HISTORIC AND DESIGN REVIEW COMMISSION

HDRC CASE NO: 2022-456
ADDRESS: 902 E GRAYSON ST
LEGAL DESCRIPTION: NCB 992 BLK 1 LOT 15
ZONING: R-6, H
CITY COUNCIL DIST.: 2
DISTRICT: Government Hill Historic District
APPLICANT: ERIN OSHAUGHNESSY/OSHAUGHNESSY ERIN E
OWNER: ERIN OSHAUGHNESSY/OSHAUGHNESSY ERIN E
TYPE OF WORK: Construction of a carport, driveway modification
APPLICATION RECEIVED: September 09, 2022
60-DAY REVIEW: Not applicable due to City Council Emergency Orders
CASE MANAGER: Jessica Anderson

Historic and Design Review Commission
Design Review Committee Report

PROPOSED MODIFICATION OF EXISTING LEAN-TO CARPORT – 902 E. GRAYSON:
REMOVE 44" FROM FRONT OF CARPORT.

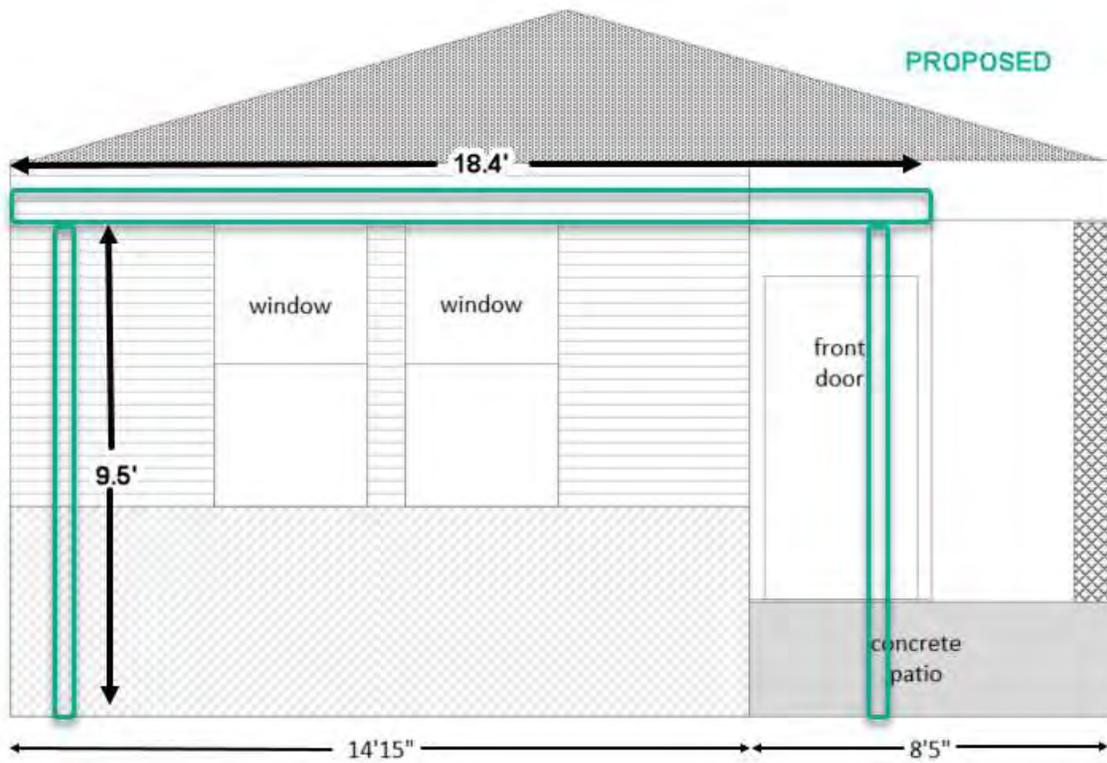
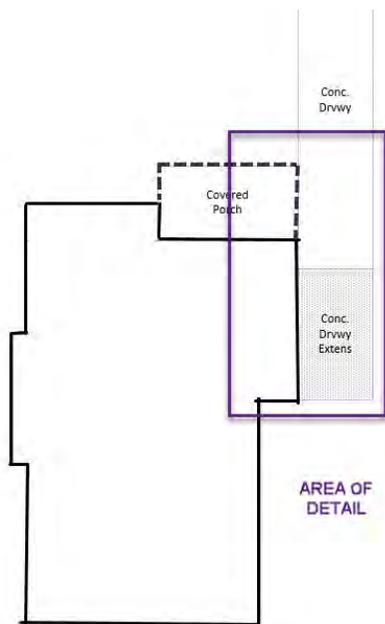
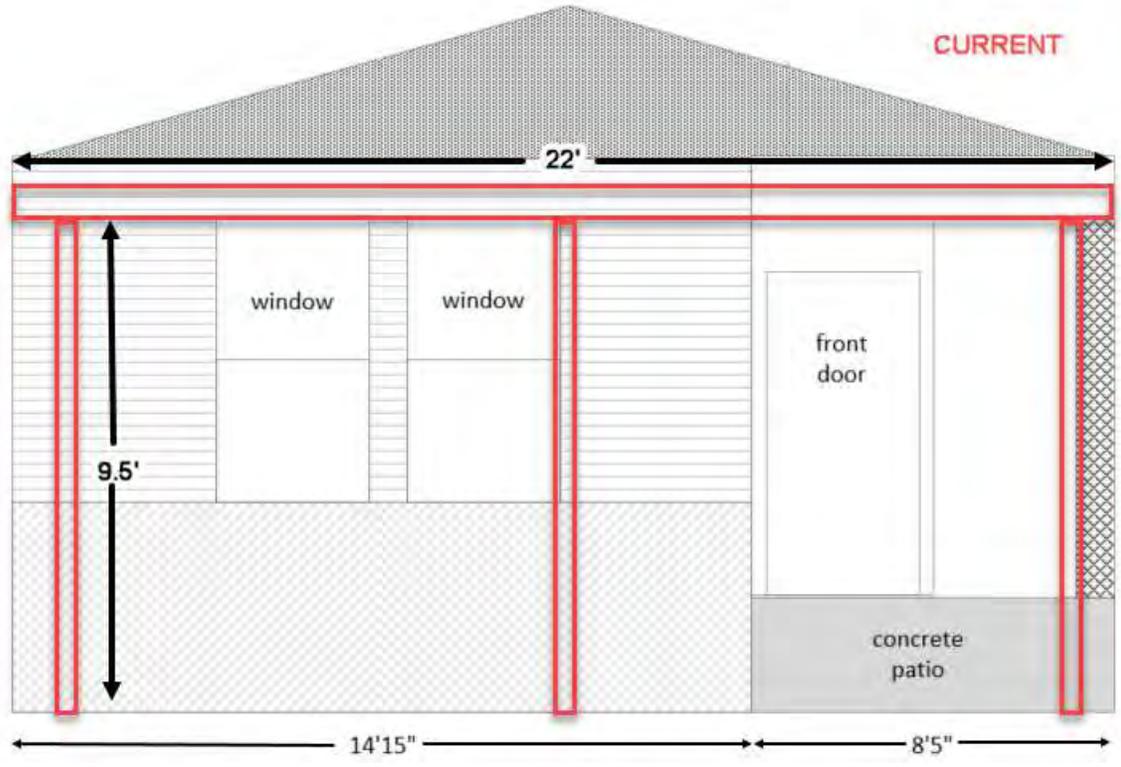
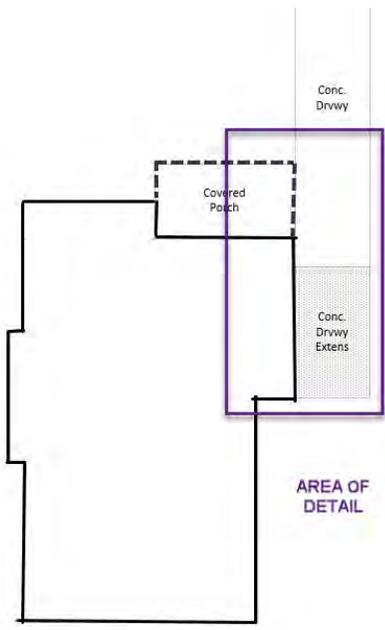
Savino: You're losing out—you're not getting the product you deserve because of his actions. Your house faces Fort Sam, but the pattern of parking beyond face of house is consistent along block, including attached coverings a little further back. Hope these contractors put the client first.

Cervantes: Agree with Monica regarding the contractor. Looked at it in Google earth at street level, and I don't think it's that bad. But getting into compliance is important. Is there a rendering? At some point, you may want to look at getting wood, something nicer.

Mazuca: Agree—sorry you got a contractor who was lax about code and the requirements of the neighborhood. Next time around, built it out of wood, or bite the bullet and redo it now.

O'Shaughnessy: We gave it a lot of thought, didn't just throw it yep there. But I do think it will look better if it's not all the way to the front. But I can't take it back too much farther or it won't cover my car.

Current carport size = 22' x 10' x 9.5'

Proposed carport size = 18'4" x 10' x 9.5'

Photographs	
-------------	--

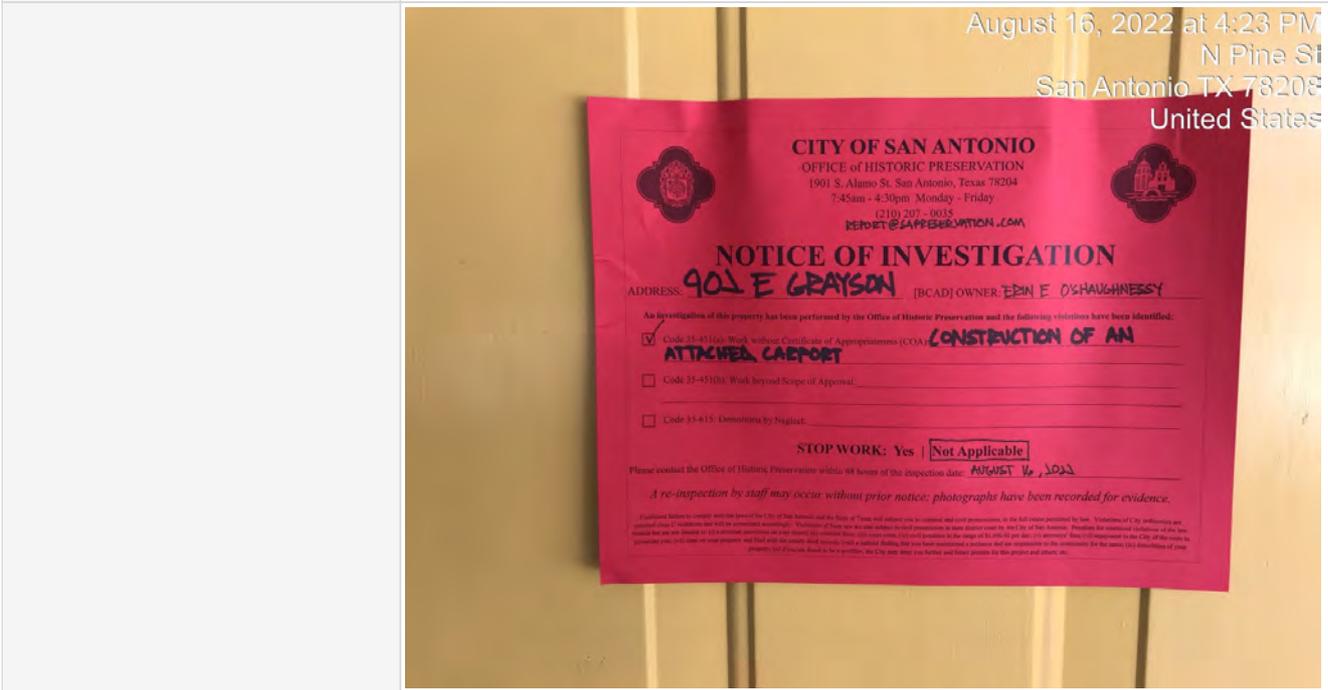
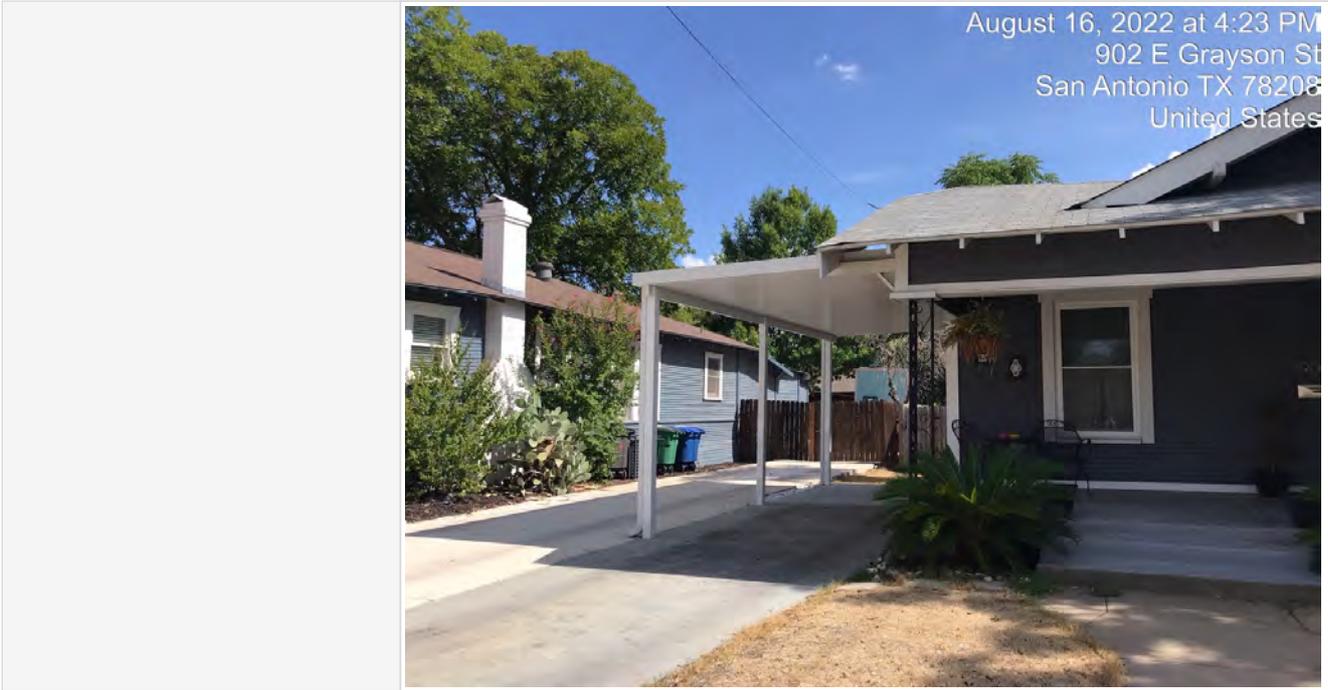
Date	08/16/2022
Time	04:15 PM (-5 GMT)
Context	citizen report
Present Staff	Edward Hall
Present Individuals	None
Types of Work Observed	New Construction
Amount of Work Completed	Completed
Description of work	Construction of an attached carport.

Violation Type	No Certificate of Appropriateness (Code 35-451a)
OHP Action	Posted "Notice of Investigation"
Will post-work application fee apply?	To be determined
